RIDE THE DUCKS INTERNATIONAL

Bulletin No. SB-00-08-13

SERVICE BULLETIN

REASON FOR RELEASE: To ensure the captain's station CO2 fire bottles (safety pin) is not being obstructed due to the close proximity of an appliance.

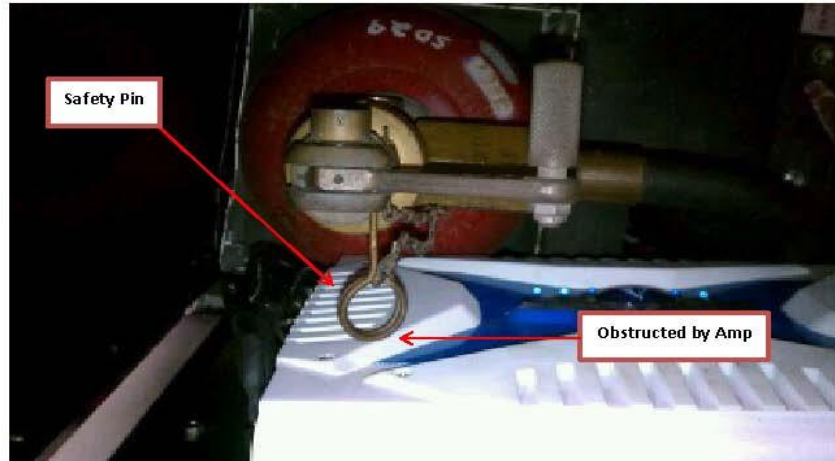
1. Examine all Duck CO2 fire bottle (Safety Pins)
2. If pin is obstructed by the stereo amplifier or other, loosen the nut directly under the pull handle and rotate the head so the safety pin is no longer obstructed.
3. If adjustment can not be achieved, relocate the amplifier or other item in-way of safety pin.
4. If Safety Pin can be adjusted, consider moving appliances that would hamper easy removal of the bottle during annual certification and weighing.
5. Notify RTDI Fleet Operations if you need assistance in complying with this bulletin.
[CONTACT RTDI Fleet Operations](#)
6. [Informational Photo](#)
7. [Reconcile Service Bulletin](#)
